DEVELOPMENT APPLICATION ASSESSMENT REPORT

Proposal Description: Replacement of existing signs and erection of new advertising signage for

Property Address: Lot 2 SP 20037, Howard Avenue Dee Why.

Application No: DA2009/0492

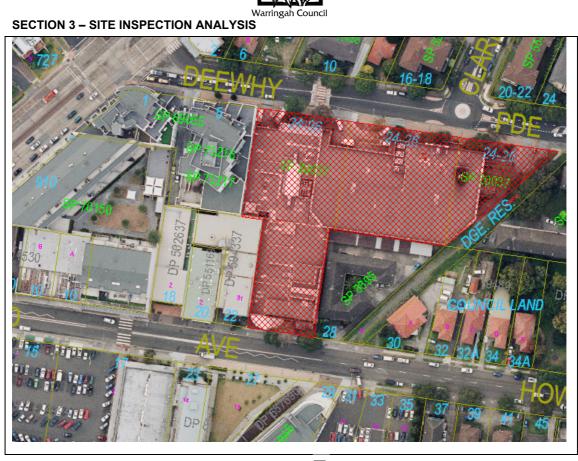
Clearly the signage proposed far exceeds the maximum allowable signage and includes new prohibited pole mounted signage.

While the signage is generally a replacement of existing signs, it is considered that the proposal should be limited to approval for only signs 1,3,4,5 & 7. In this regard the content, extent, number shape and size of these signs will satisfy the requirements of clause 53 to:

The variation to the numerical controls of this clause is supported since the proposal generally is only replacing (refacing) existing signs for "Coles". Subject to limiting the new signs as discussed the proposal is acceptable having regard to the considerations of this clause.

Suitable conditions are recommended to ensure the pylon sign (No.2) and additional wall sign (No 6) are deleted from the plans prior to issue of the CC.
